Town of Baldwin
Planning Board Meeting 11/11/21

Agenda Item – Sebago Road Solar

SEBAGO ROAD SOLAR

**CONDITIONAL USE APPLICATION FOR PLANNING BOARD REVIEW
SUPPLEMENTAL INFORMATION
Sebago Road Solar, LLC
6 Carl Burnell Road, Baldwin**

PROFILE OF GRAVEL ACCESS ROAD
 SCALE: 1" = 40' HORIZONTAL
 1" = 4' VERTICAL

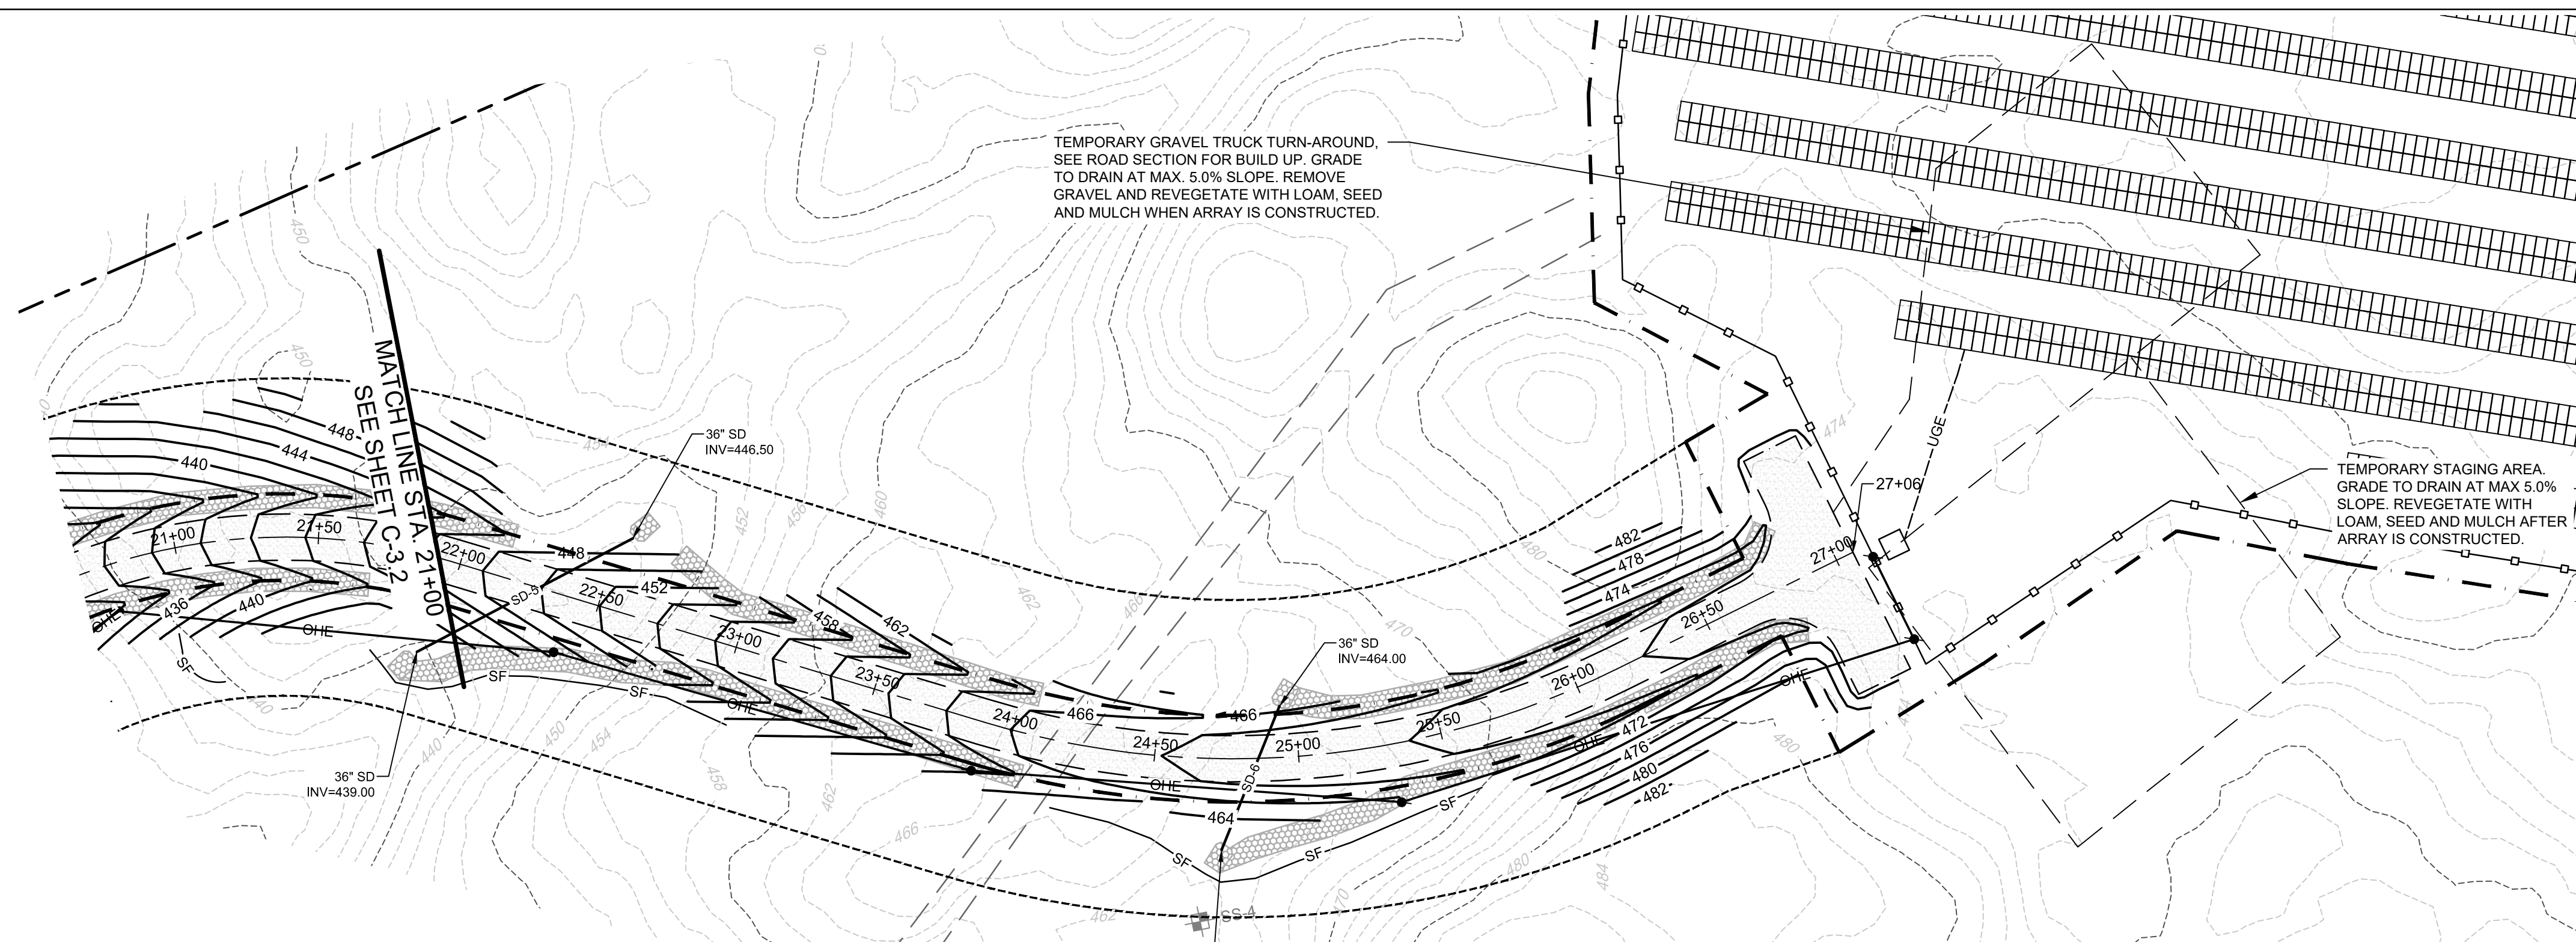
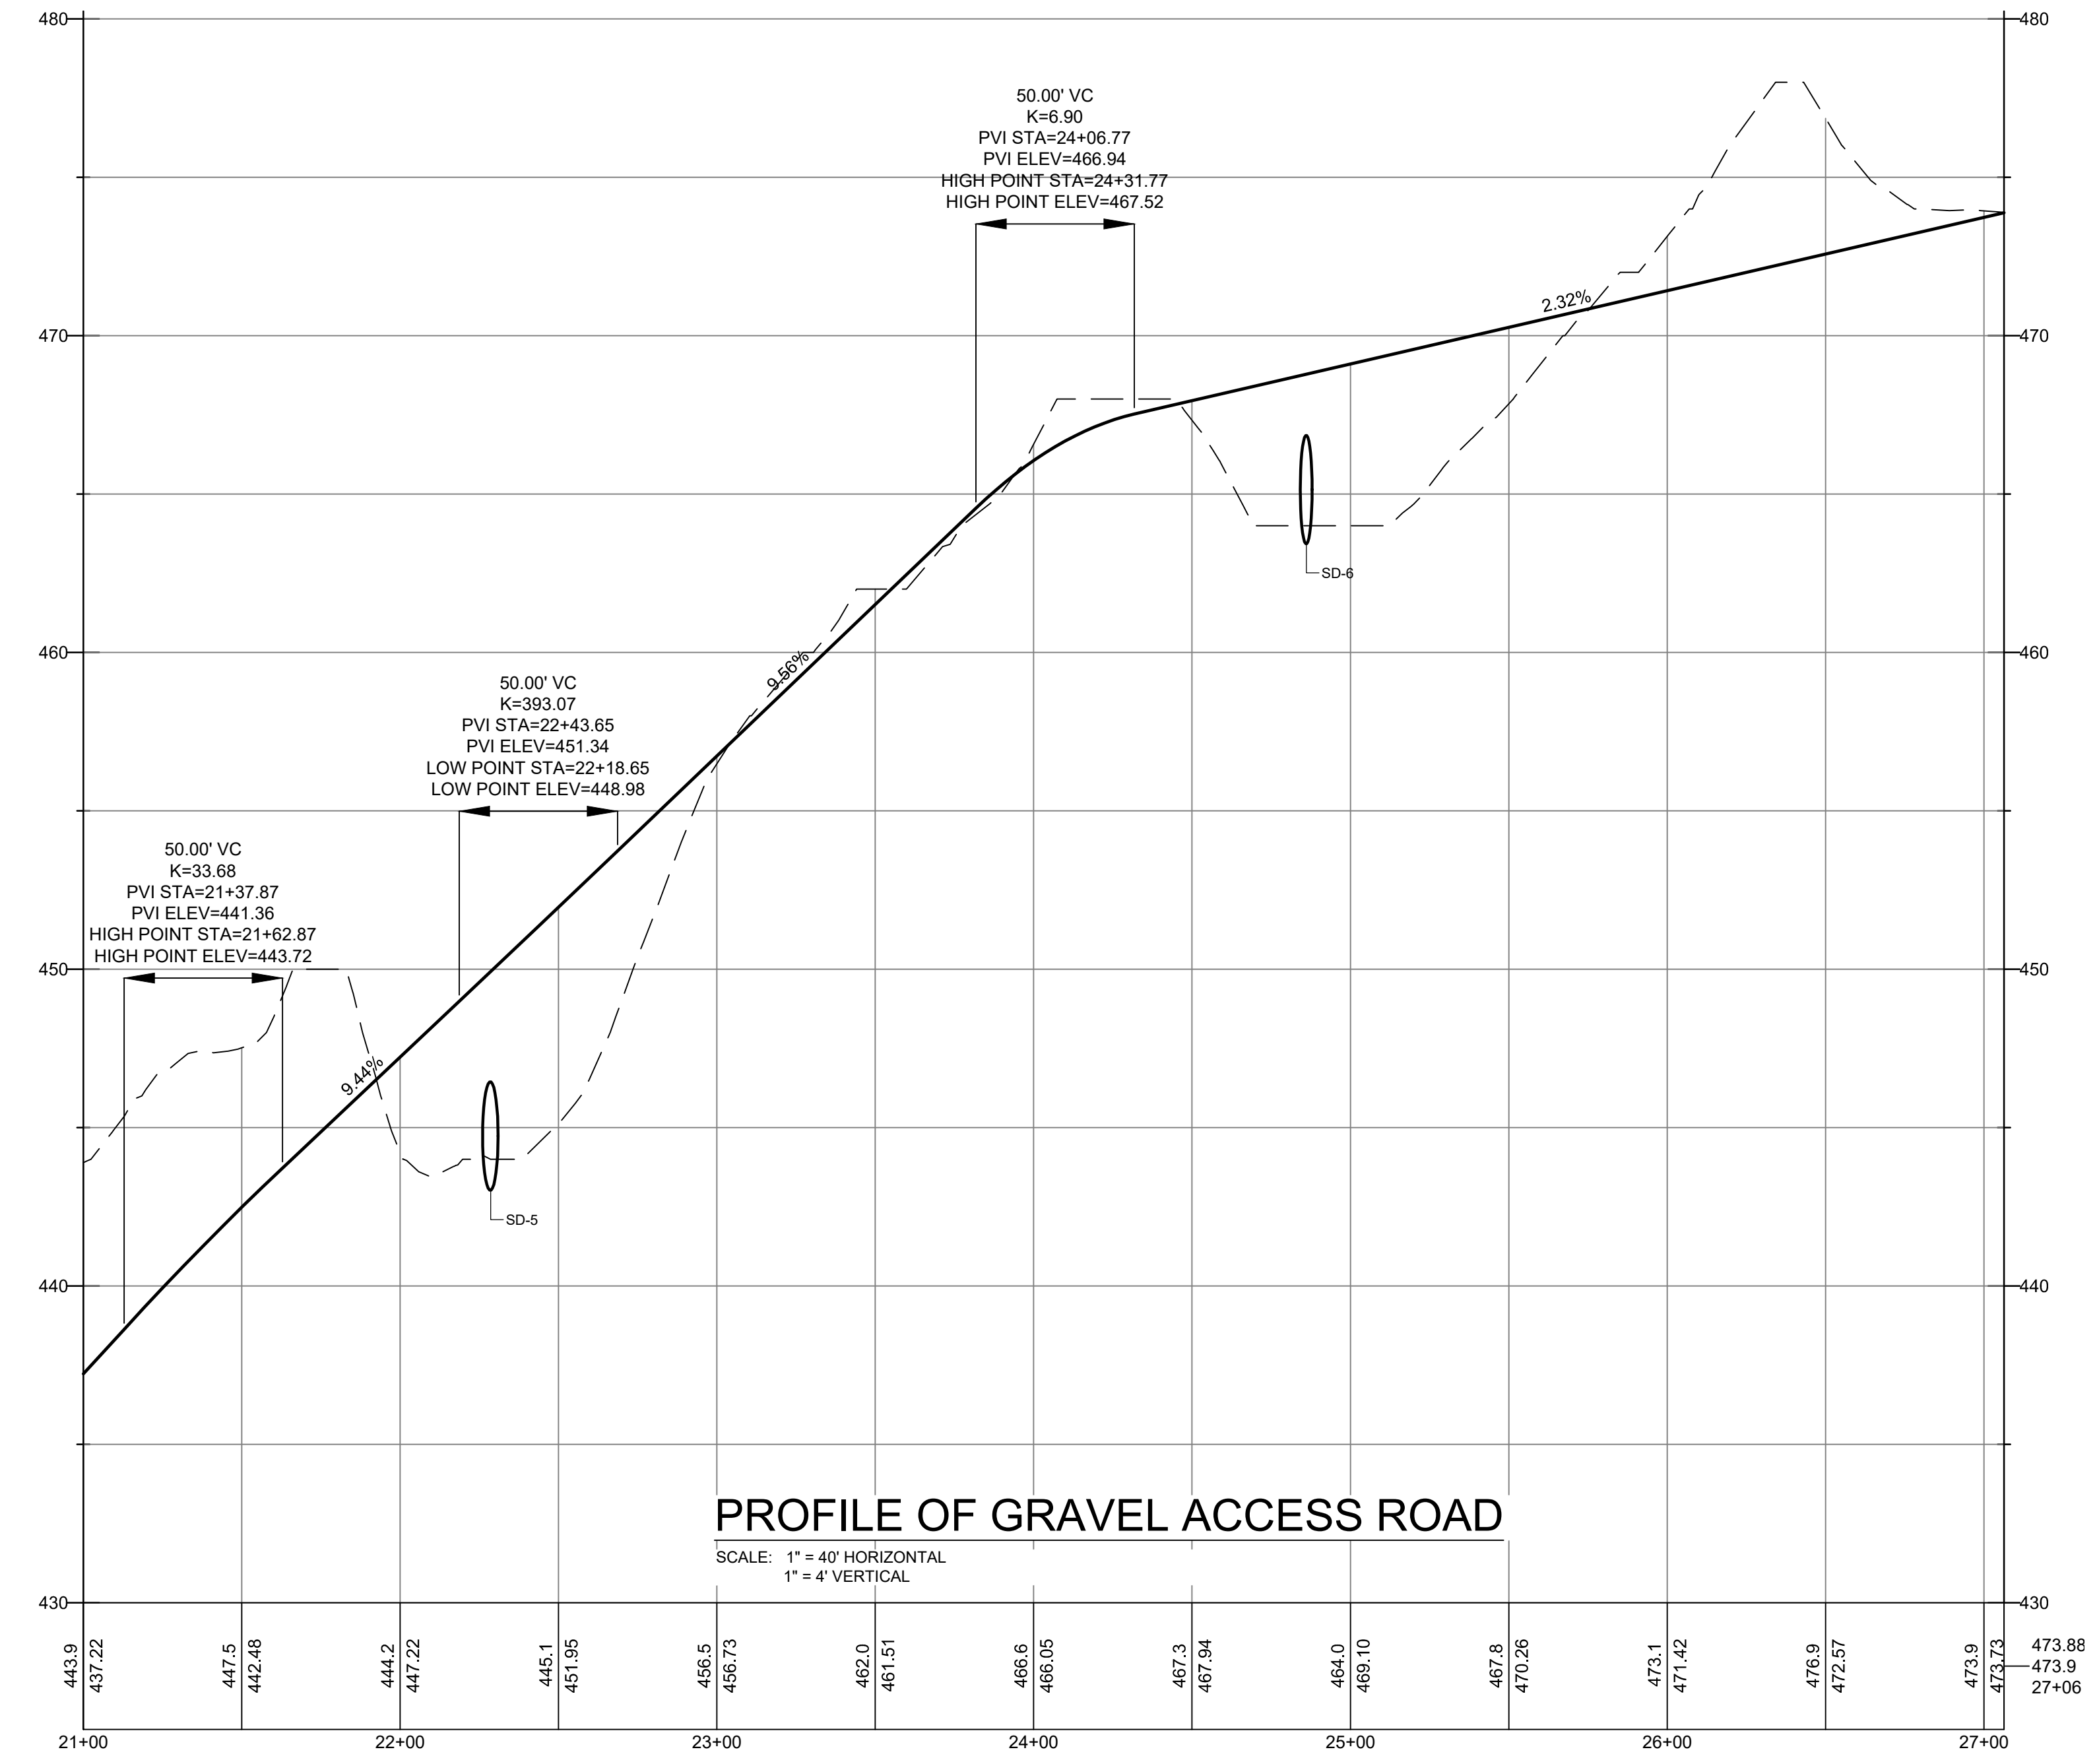
Mr. Fricker said that he hoped the applicant would address the 11% grade during the winter and whether that would be an issue. He wants to make sure the applicant has a plan for winter access. The new submissions are attached.

- Mr. Bastian said that he reached out to area contractors about the 10 or 11 percent grade an issue for construction and they said it should be fine if it is a well compacted gravel access road. In response to a question, he stated that the acces road will need to be well maintained during the winter with plowing and salt.
